REMARKS

Before proceeding to a discussion of the numerous asserted grounds of rejection based on prior art, the invention will now be summarized. The invention is directed to providing protection from electrostatic discharge (ESD) damage to a semiconductor device such as an integrated circuit. Such a circuit must provide for rapid response time, high current carrying capability and relatively low impedance when conductive. The protective circuit must also, as a practical matter, have a very small footprint since it is often preferred, for best protection, to provide a substantial number of such protective circuits surrounding a protected circuit (referred to as an internal circuit, largely for that reason). Diodes and FETs are each known for use as protective circuits and each has respective advantages as compared with the other. For example, a diode responds quickly to a potential pulse with a sharp rise in current but has a relatively high impedance. An FET has a relatively slow response time but relatively lower conductive impedance. Therefore, either device alone provides less than optimal performance for all electrostatic discharge circumstances but either may be adequate for

FIG. 4

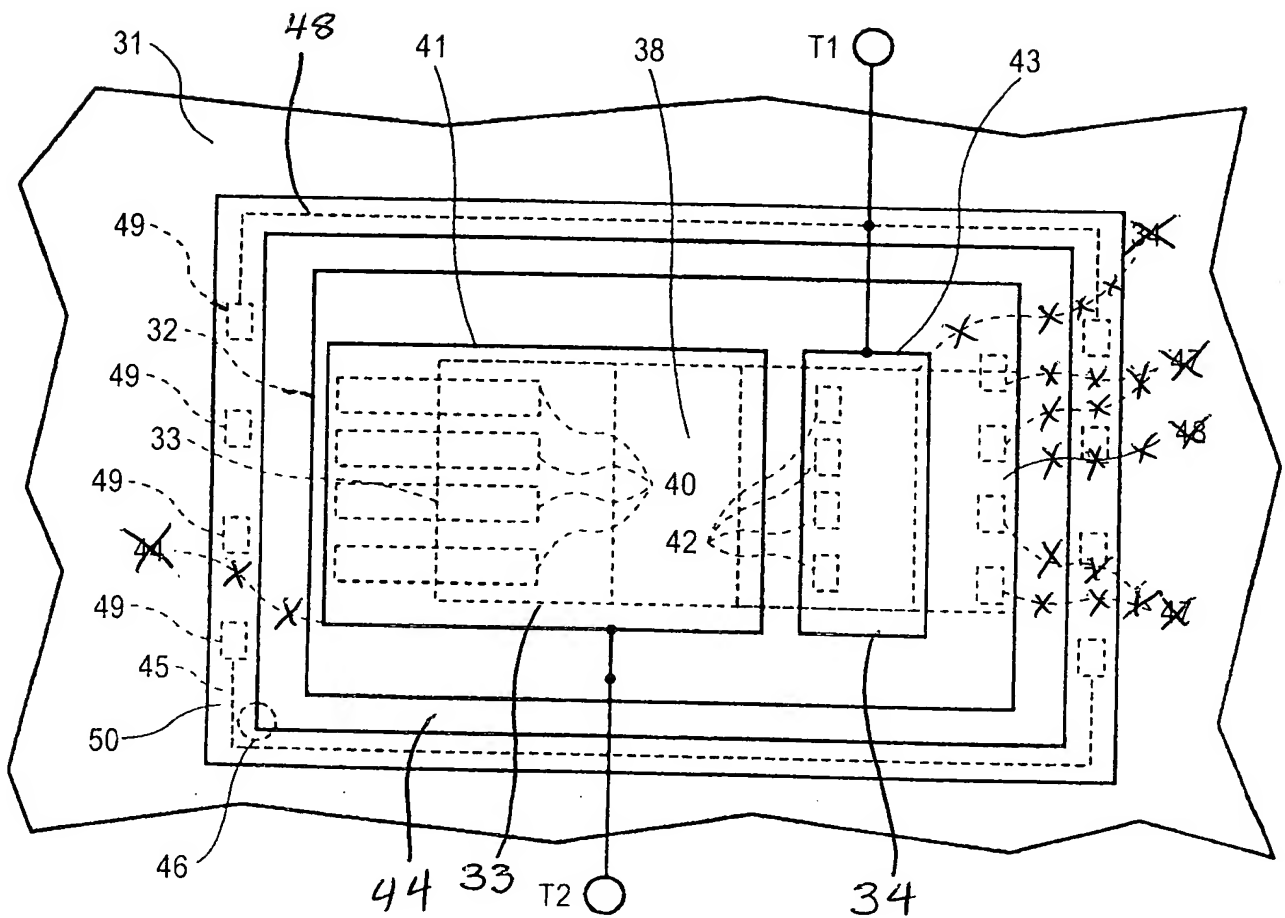
The Examiner has objected to the drawings under 37 C.F.R. §1.84 as containing reference numerals 41, 49 and 50, not found in the specification. This objection is respectfully traversed as moot in view of the amendments to the specification made above in which reference numerals 41, 49 and 50 have been added at appropriate locations.

Please approve the proposed drawing revisions as shown in red in the attached sheets containing Figures 4, 5 and 8. Corresponding corrected formal drawing sheets are filed concurrently herewith.

FIG. 8

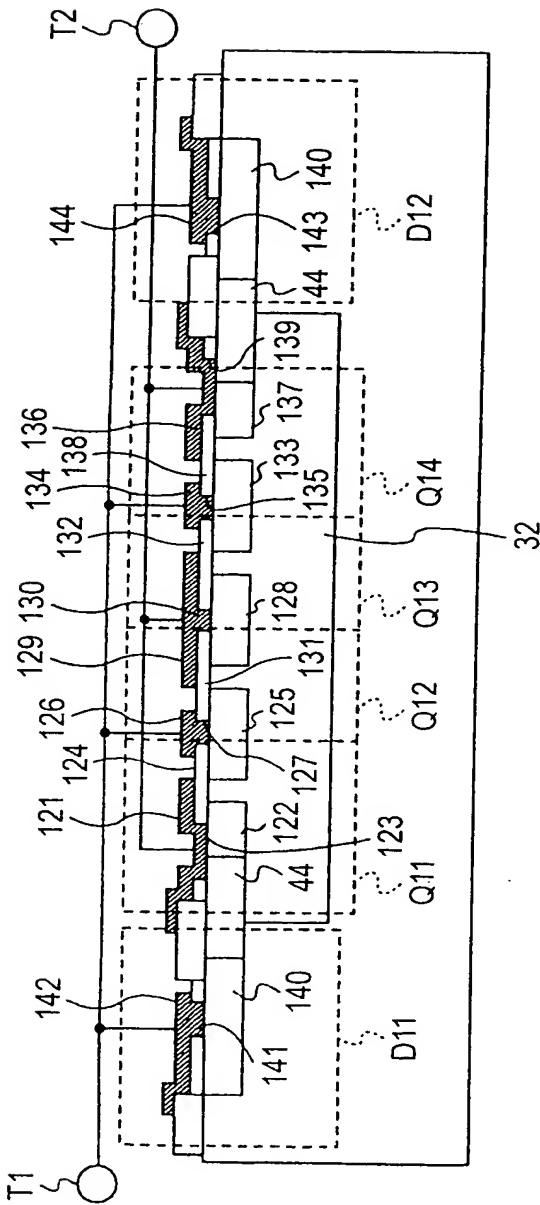
The Examiner has further objected to the drawings under 37 C.F.R. §1.83 as failing to illustrate claim 4 and rejected claim 4 under 35 U.S.C. §112, first paragraph, as being unsupported by enabling disclosure. This objection and rejection are respectfully traversed.

It is respectfully submitted to be well-accepted nomenclature and terminology in the art to refer to a single structure connecting respective regions or structures of different transistors (which are particularly common in matrix arrays such as memories where the common gate connections and common source drain connections form respective word and bit lines) as "common" or "shared" such as "shared gate" or "shared drain". In the case of the embodiment of the present invention shown in Figure 6 and 7, a plurality of transistors are connected in parallel for increased current carrying capability as schematically shown in

Figure 8 or in plan view in Figure 6 and thus have electrically common or shared sources, gates and drains. Specifically, as discussed on pages 14 and 15 of the specification in regard to Figure 6, particularly at page 15, lines 9 - 27, where it is explicitly disclosed that Q11 and Q12 share a common drain diffused region 125 and drain wiring 126, Q12 and Q13 share a common source diffused region 128 and common source/gate wiring 129, and so on through Q14. The drain wiring and source/gate wiring for each pair of transistors is also commonly connected in respective integral structures and are thus also "common" or "shared". Therefore, it is clear that the Examiner is incorrect in regard to both the objection and rejection since an enabling disclosure and clear illustration are clearly provided for a plurality of transistors having shared gates and drains. However, to even more clearly resolve these issues and in response to the appearance that the Examiner may be asserting that the *effective region* of the gates of different transistors cannot be in the same place but must be located in accordance with channel regions which are necessarily spaced from each other, claim 4 has been amended to refer to shared gate and drain *structures*. Accordingly, reconsideration of this objection and this rejection are respectfully requested.
